# Errata Sheet

**Product Family:** DL305

**Manual Number** D3-USER-M

**Revision and Date** 1st Edition, Rev. D; January 2010

Page 2-12. Base Wiring

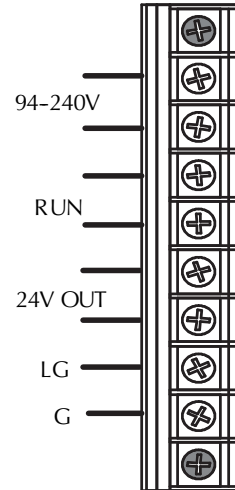
On newer 110-240 VAC bases, the terminal strip has been re-designed and does not have different terminals for 110VAC and 240VAC connections. If you have one of these re-designed bases the terminal strip will look like this:

Page 3-9. DL330/DL330P CPU Setup; Installing the UV PROM Option in the DL330/DL330P CPU

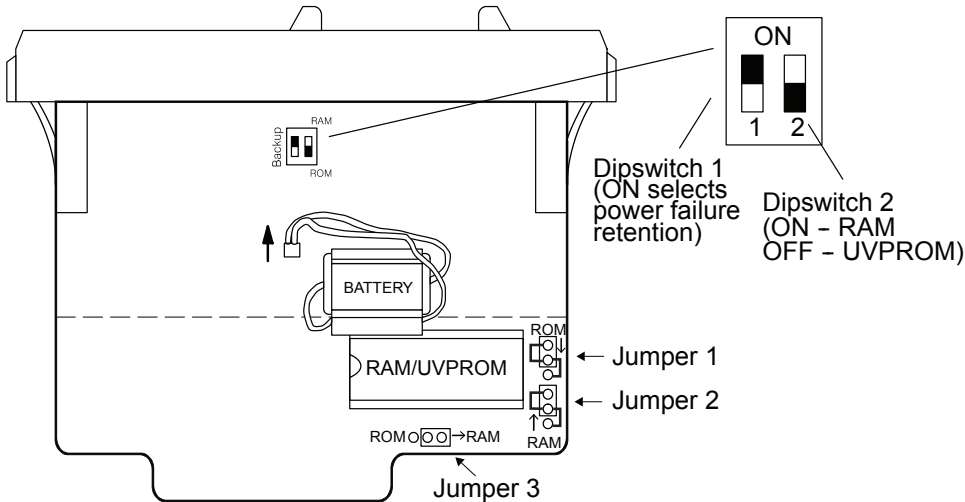
The drawing showing the jumpers is missing the silkscreen jumper lines and arrows for jumpers 1, 2 and 3. Refer to this drawing.

Page 4-16. Setting the Base Switches; 5 Slot Bases

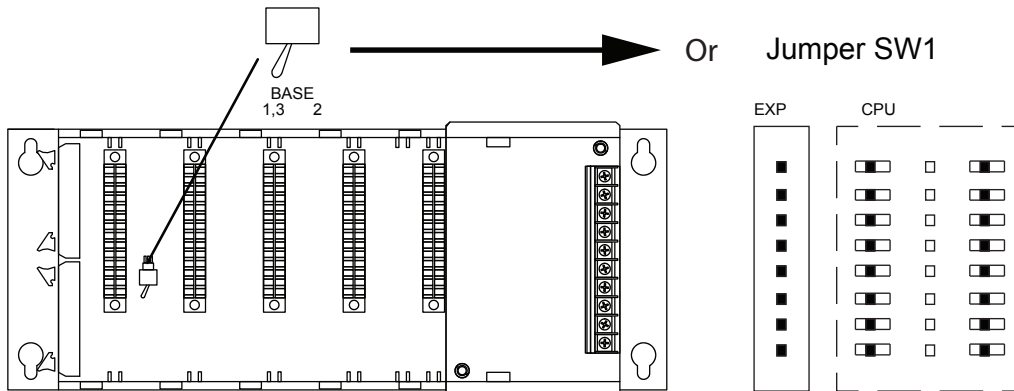
Replace the drawing of the 5 slot base with this one. Newer 5 slot bases have jumper switch SW1 instead of the toggle switch to set whether the base is a local CPU base or an expansion base.

NOTE: Older bases have a toggle switch to set the base as the CPU local base, the first expansion base, or the second (last) expansion base. Newer bases have the jumper SW1 in place of the switch.

### Reset the PLC to Factory Defaults

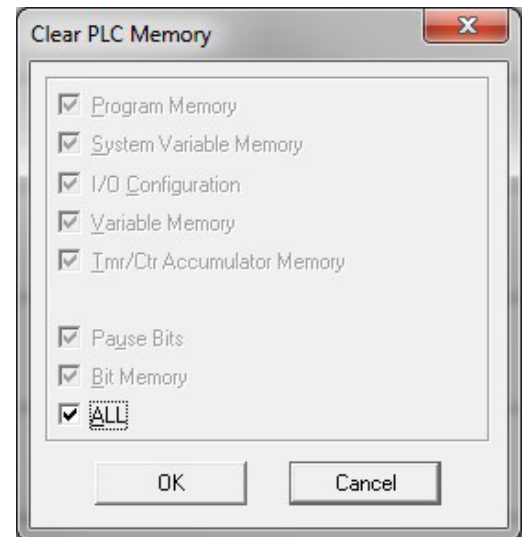
Page 13-13. Add the following to the end of this chapter (right after END Instruction Placement):

Step 1 – While connected to the PLC with DirectSoft, go to the PLC menu and select; “Clear PLC Memory”. Check the “ALL” box at the bottom of the list and press “OK”.

Step 2 – While connected with DirectSoft, go the PLC menu and then to the “Setup” submenu and select “Initialize Scratch Pad”. Press “Ok”.
